Prepared Discussion : 1A

Design Implications of Damage Observed
in the Olive View Medical Center Buildings
by V.V. Bertero, B. Bresler, L.G. Selna,
A.K. Chopra, and A.V. Koretsky

DESIGN IMPLICATIONS OF DAMAGE OBSERVED
IN THE OLIVE VIEW MEDICAL CENTER⁽¹⁾

²Discussion of question by Prof. Aoyama regarding failure of exhaust pavilion prepared by L.G. Selna.

Fig. 1 Exhaust Pavilion Joint Damage

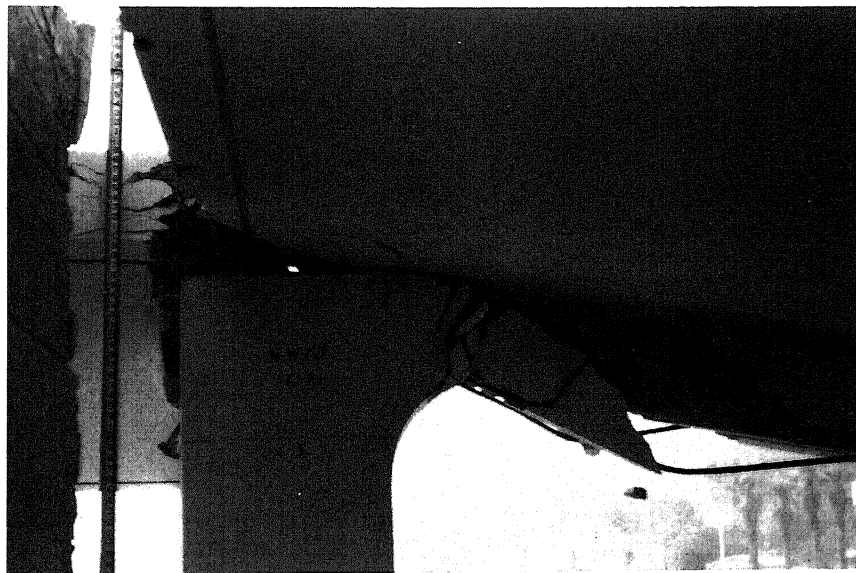
1. The reason for failure of the exhaust pairlion was the torsional failure of cantilever beams which could be due to the presence of high torsional moment under gravity loading intensified by vertical fluttering of slabs and horizontal swaying as a frame. Column bar detailing may not be the basic reason.
2. I think stairtowers A,B and D fell primarily because of large story drift in the first story of the main building. The second floor of the main building pushed the tozer, imposing large rotation of wall and prohibitive axial deformation of ground story columns below the wall. I think these columns failed in compression and tension, not in shear.

L.G. Selna⁽²⁾ - The observation by Prof. Aoyama regarding the principal failure mode of the exhaust pavilion is an alternate to the one made by the authors. This is most interesting because it shows that even for this seemingly uncomplicated structure many opinions can arise. The authors contend that the failure was due to poor detailing of column bar anchorage while Prof. Aoyama claims that the failure was due to high torsional moment exerted by the sunshade slab on the edge beam. Other reports^(3,4) also have stressed that torsion was significant in the failure.

The issue is whether the edge beam failed due to torsion or that the joint failed due to poor bar detailing. In the prototype flexural and torsional force components were present in the edge beam during the earthquake. These components change to biaxial moments when they go from the edge beam through the joint to the column. A structural dynamics math model⁽⁵⁾ which used the Pacoima Dam accelerogram⁽³⁾ as input showed that the maximum flexural component was 5.5 times greater than the torsional component in the edge beam.

found by this method was nearly equal to the maximum moment and shear found from the structural dynamics model thereby indicating that failure should have occurred in the joint. The math model studies confirm that the joint should have failed due to poor detailing before the edge beam failed due to torsion.

Field studies also confirm that moment in the joint was the principal cause of the failure. The sequence of the failure can be reconstructed by study of one of the damaged joints (Fig. 1). The failure started at the top left hand side of the column due to flexural tension. The tension crack then propagated to the right hand side of the column where a tension failure was initiated in that part of the edge beam protruding below the shade slab. There was no reinforcing steel at that elevation in the edge beam to resist the tension so that a complete failure ensued. Note that the #6 bars at the bottom of the edge beam popped out. It can be seen in Fig.1 that the direction of the diagonal failure which resulted as concrete dropped away from the inside face of the edge beam is opposite to a crack which would result from torsion due to gravity plus dynamic vertical load.

Based on these analytical and field studies it was concluded that the poor bar detailing was the principal cause of the failure.
